ADDENDUM #06

PROJECT: **UPPER POTTS GROVE TOWNSHIP NEW MUNICIPAL COMPLEX**
PROJECT #: 22-0058
ISSUE DATE: **May 08, 2024**

- a. **02.N-1 - NOTES**
- b. **06.ES-1 – EROSION & SEDIMENT CONTROL PLAN**
- c. **08.ES-3 – EROSION & SEDIMENT CONTROL DETAILS**
- d. **15.SWM-3 - POST CONSTRUCTION STORMWATER MANAGEMENT PLAN**
- e. **16.SWM-4 – POST CONSTRUCTION STORMWATER MANAGEMENT NOTES/DETAILS**

EROSION & SEDIMENTATION CONTROL PLAN

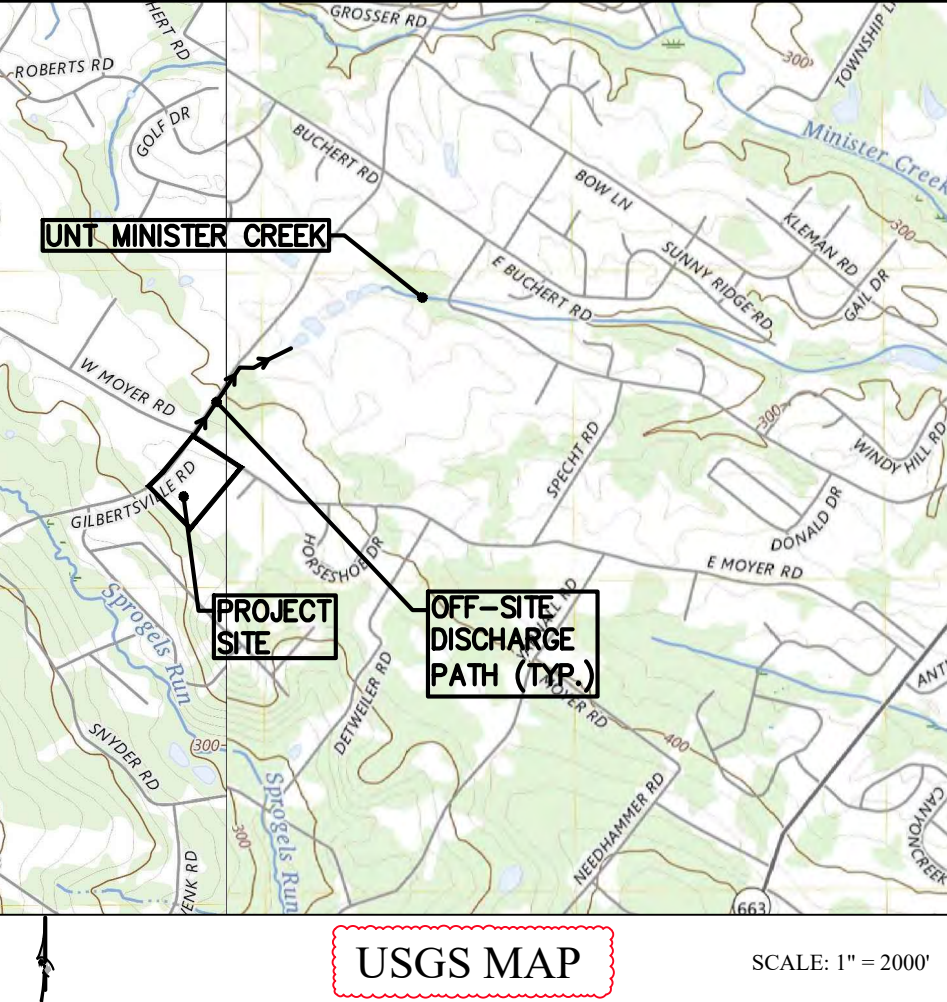
- INFILTRATION TESTING RESULT CHART UPDATED WITH 2 NEW TEST PITS FOR BMP#1 (TP5 & TP6)
- DURING CONSTRUCTION DRAINAGE AREA TO BMPs ADDED TO THE PLAN.
- PROPOSED INLET PROTECTION REPLACED BY TEMPORARY INLET SEALS.
- DISCHARGE POINT #2 (DP 002) ADDED TO THE PLAN.
- CONSTRUCTION SEQUENCE ITEM #28 REVISED.
- CONSTRUCTION SEQUENCE ITEM #29 ADDED.

- PROFESSIONAL SEAL ADDED TO PLAN.
- SOIL LIST CHART UPDATED.
- LOCATION MAP REPLACED WITH USGS MAP.
- CONSTRUCTION SEQUENCE REVISED.
- FILTER SOCK LOCATION, LENGTH, AND DIAMETER REVISED.
- ROCK CONSTRUCTION ENTRANCE CHANGED.
- LIMIT OF DISTURBANCE AREA EXPANDED.
- CONCRETE WASHOUT AREA SLIGHTLY MOVED.
- WATER/SAND JERSEY BARRIER ADDED TO THE PLAN.
- VEGETATED SWALE #1 CALLOUT ADDED TO THE PLAN.

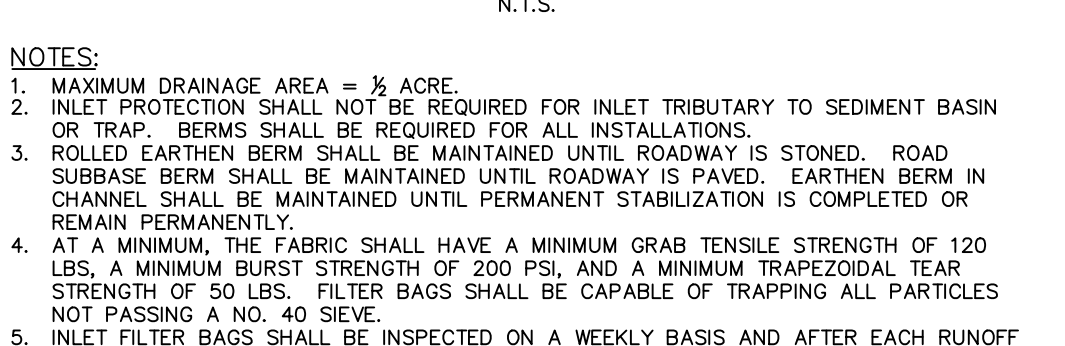
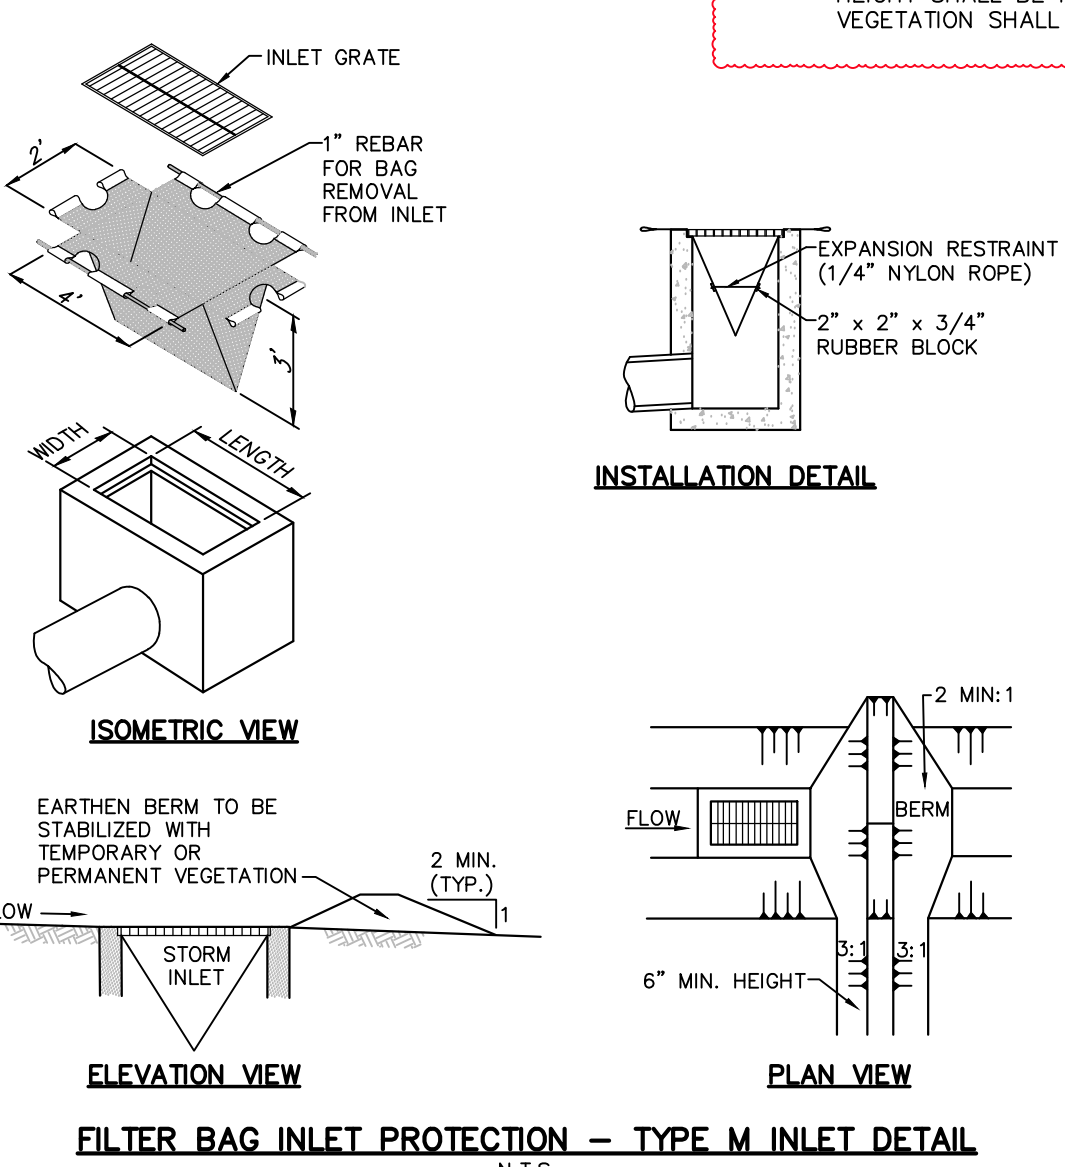
- ITEMS INCLUDED IN 04/11/2025 REVISIONS:
- PROFESSIONAL SEAL ADDED TO PLAN.
 - NEW ROCK CONSTRUCTION ENTRANCE DETAIL ADDED TO THIS SHEET.
 - VEGETATED SWALE DETAIL ADDED TO THIS SHEET.
 - ROCK FILTER OUTLET DETAIL REVISED.

- ITEMS INCLUDED IN 05/01/2025 REVISIONS:
- FILTER BAG INLET PROTECTION FOR 2'x2' YARD DRAIN DETAIL OMITTED.

POST-CONSTRUCTION
STORMWATER
MANAGEMENT
NOTES/DETAILS

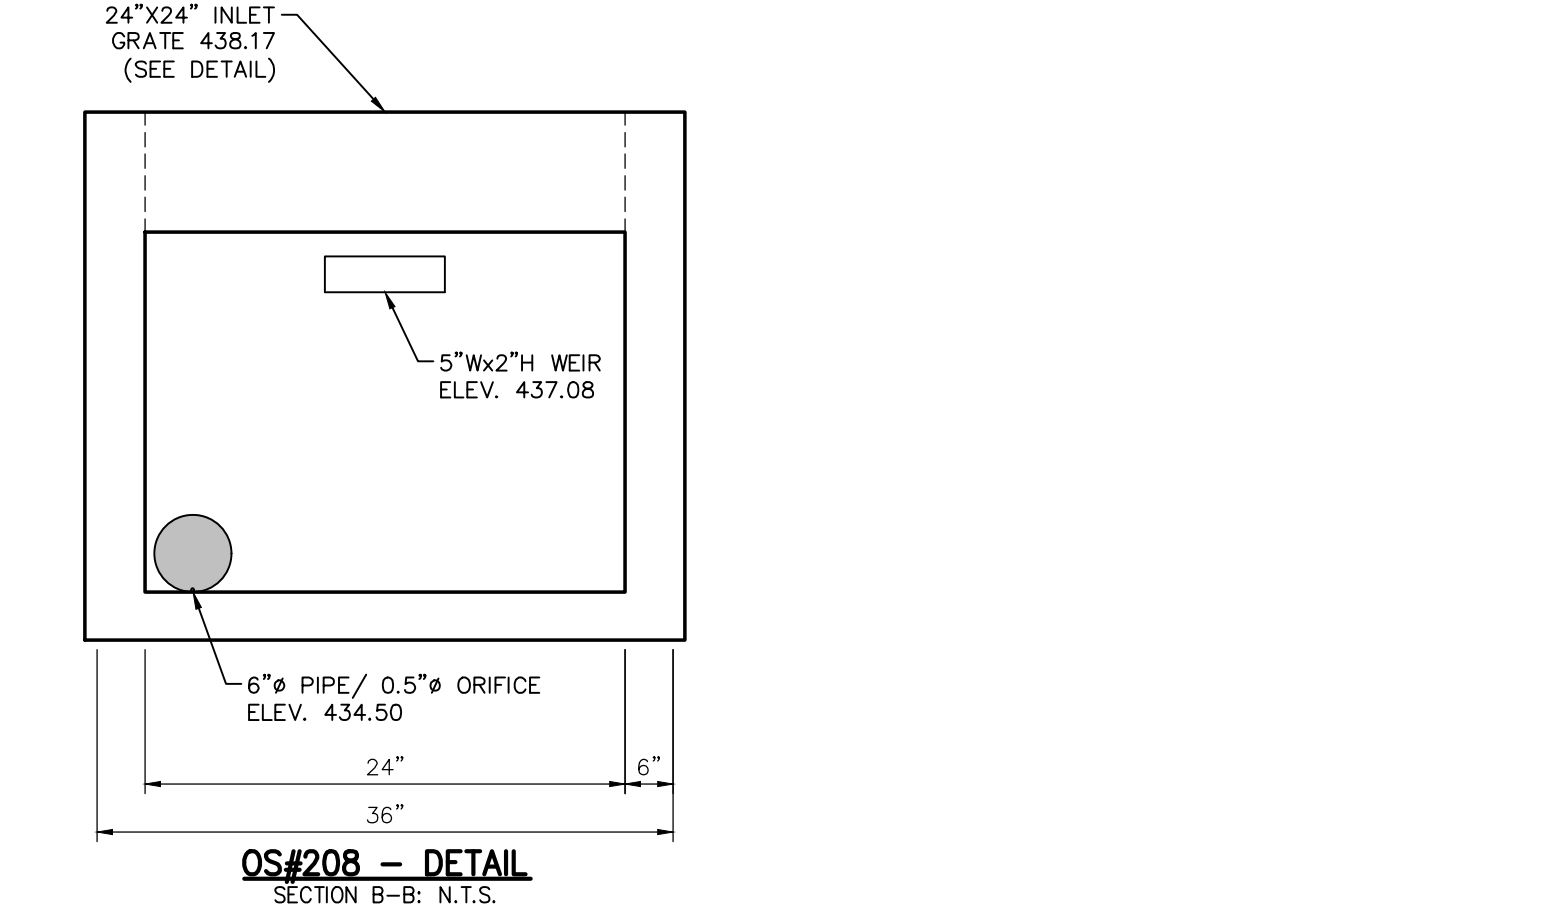
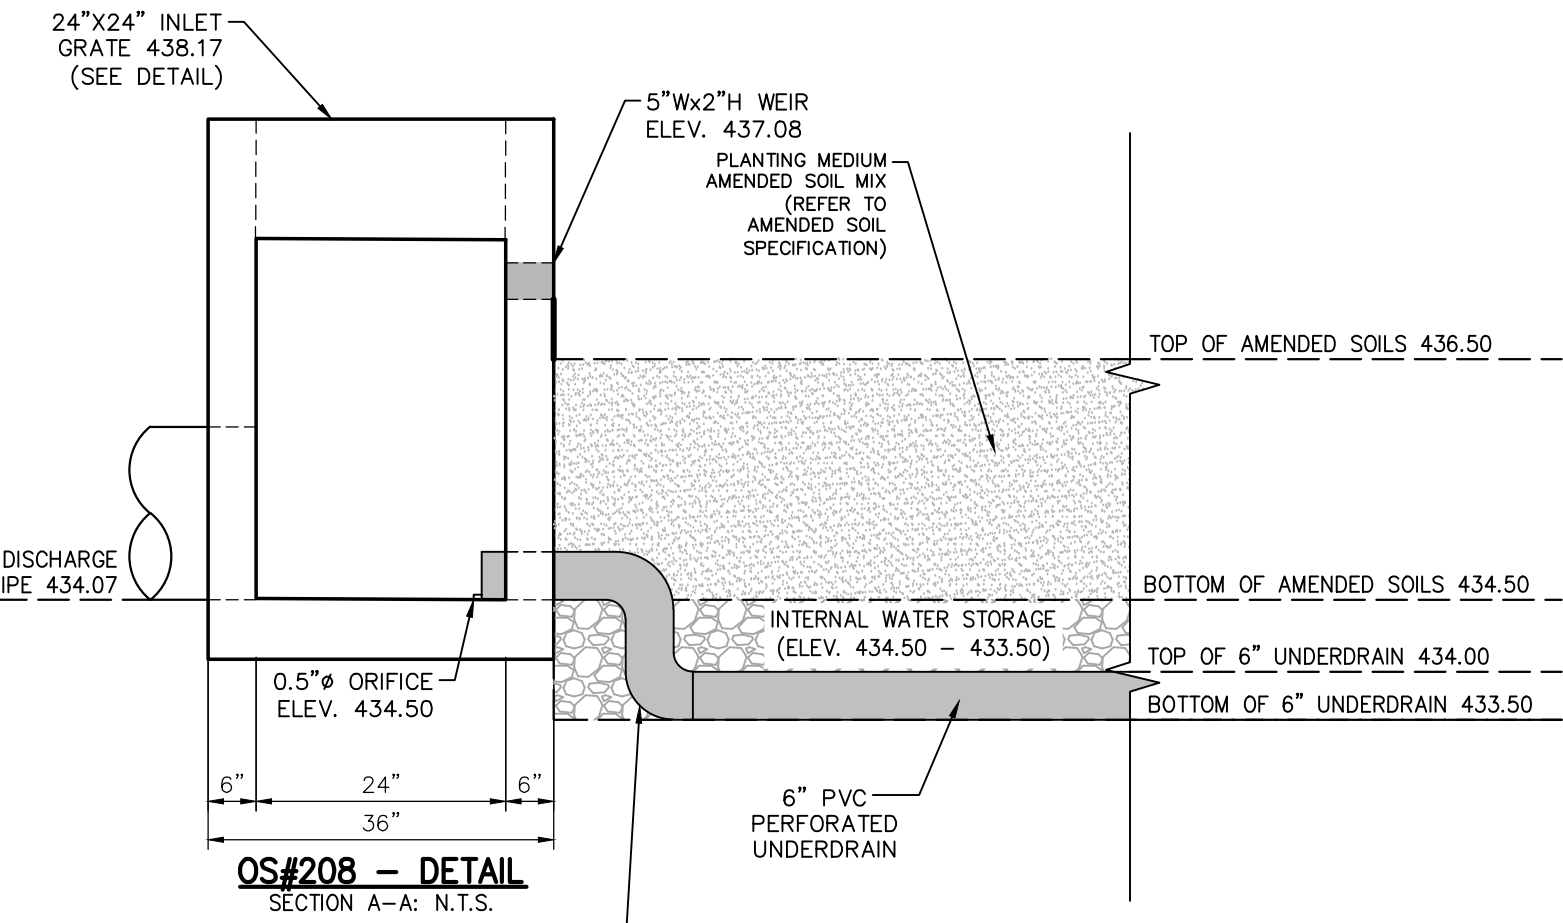
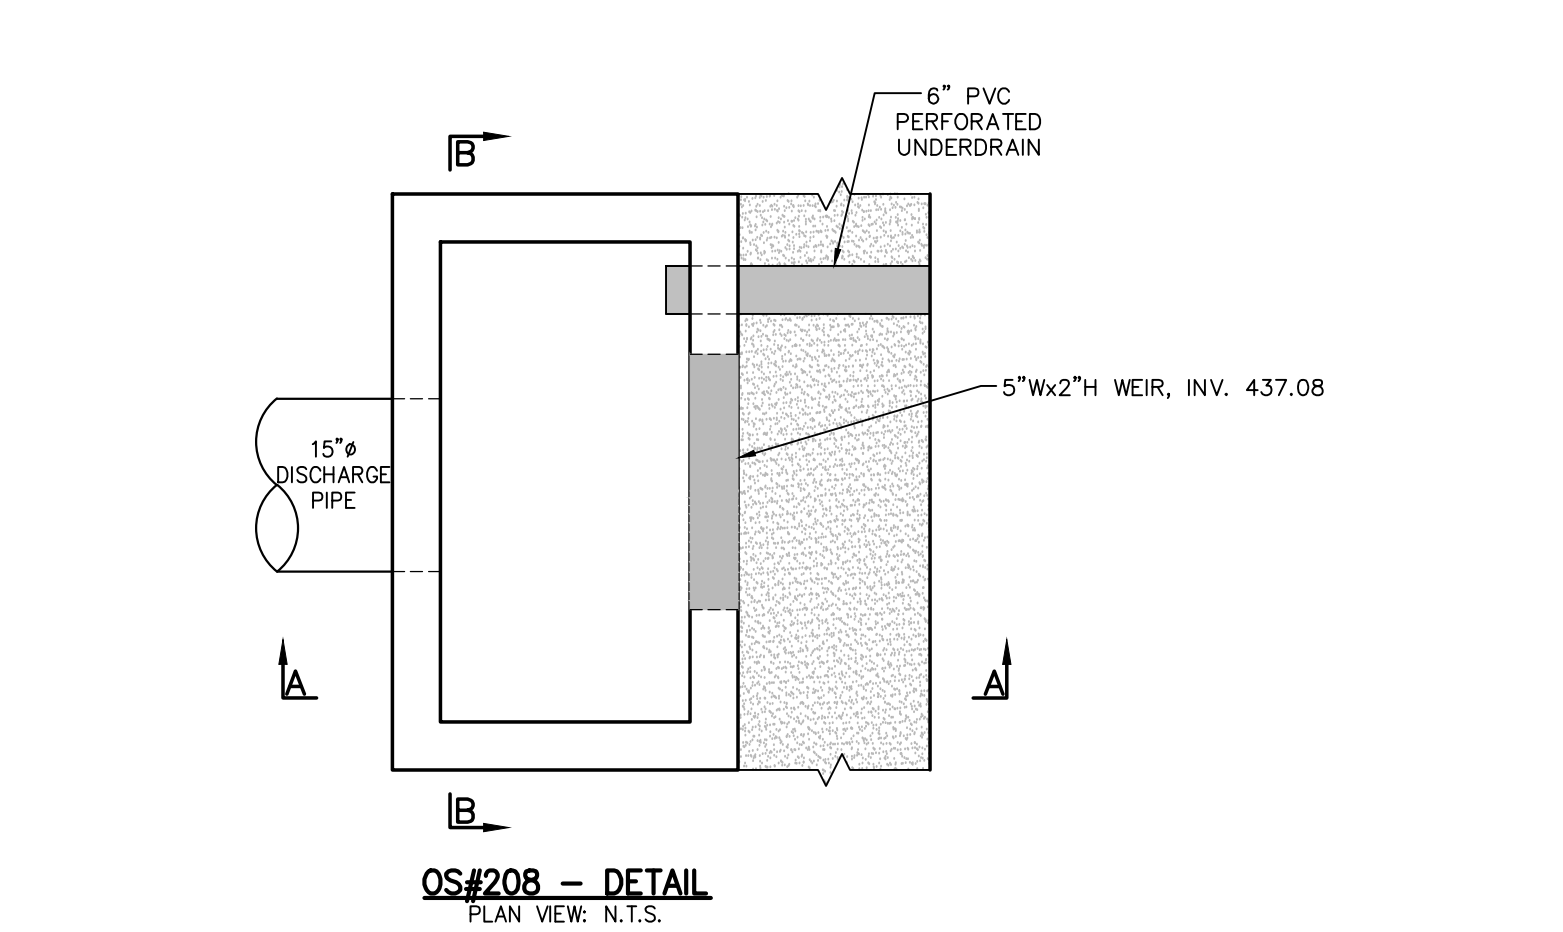
- PROFESSIONAL SEAL ADDED TO PLAN.
- BMP #1 DETAIL REVISED TO INCLUDE UNDERDRAIN, STONE, GEOTEXTILE FABRIC, AND CLEANOUT.

- OS#208 POND LINER OMITTED.
- BMP #1 BIORETENTION AREA DETAIL- DISCHARGE PIPE INVERT ELEVATION REVISED.
- BMP #1 BIORETENTION AREA DETAIL- UNDER DRAIN INVERT ELEVATION ADDED.
- CONSTRUCTION SEQUENCING NOTE REVISED.
